SUBDIVISION COMMITTEE
METROPOLITAN AREA PLANNING COMMISSION

STAFF REPORT
(Preliminary Plat)

CASE NUMBER: S/D 91-63 - REFLECTION RIDGE 8TH ADDITION

VICINITY MAP:

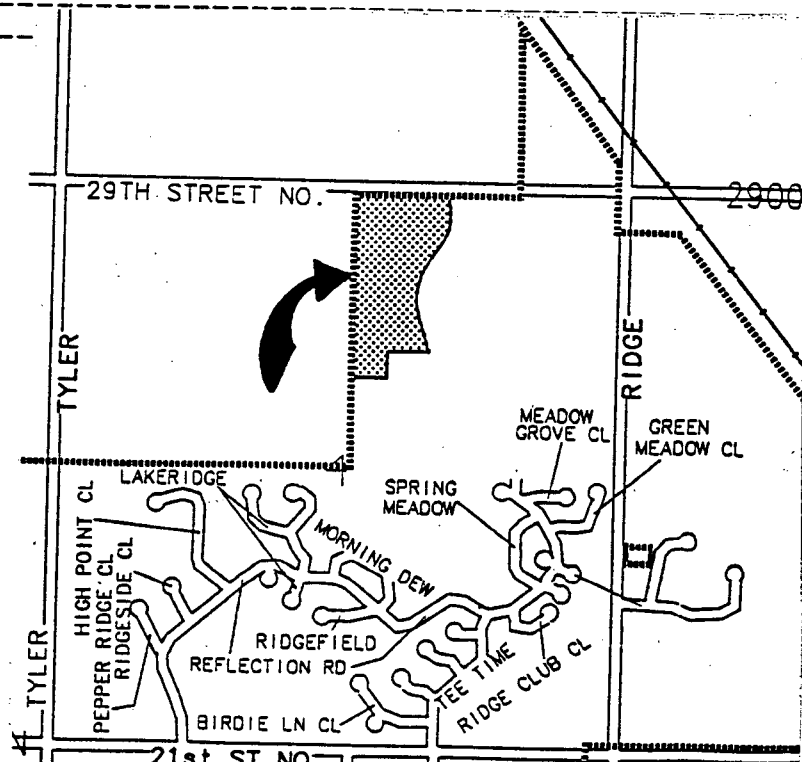
- H. When this area was reviewed as an overall preliminary plat it was indicated that: "Section 7-201(v) of the Subdivision Regulations notes: "When a proposed subdivision is adjacent to unplatted property, the platting of stub streets to provide future access to the adjacent unplatted tract, shall be provided." For this particular plat, two such stubs need to be provided to the tract west of this site. The extension of Meadow Pass along the south line of Blocks 4 and 5, and the extension of Meadow Crest south of Block 6, would appear to be two possibilities. At the most, a decrease of one lot may be involved and neither street would damage any significant portions of the existing rows of trees on each tract."

One of the above suggested connections would have been along the south line of this plat or south of lots 68 and 72. When the final plat of the Reflection Ridge 7th Addition was approved, however, no such connection was required.

This plat though still involves the most substantial frontage to the unplatted property to the west and a connection, as required by the Subdivision Regulations should be required. To satisfy this requirement, the applicant is proposing a "contingent" dedication in the area of lots 21 and 14. It is not clear what the "contingency" is, when the right-of-way will be dedicated and how to enforce separate dedication over a platted lot. In addition, the present location, being only 300 feet from 29th St. with the remaining property to the south having no connection, is only moderately beneficial for interconnecting neighborhoods. It is recommended therefore that the Subdivision Committee require an out right street dedication and that a more central location or more than one stub street be provided.
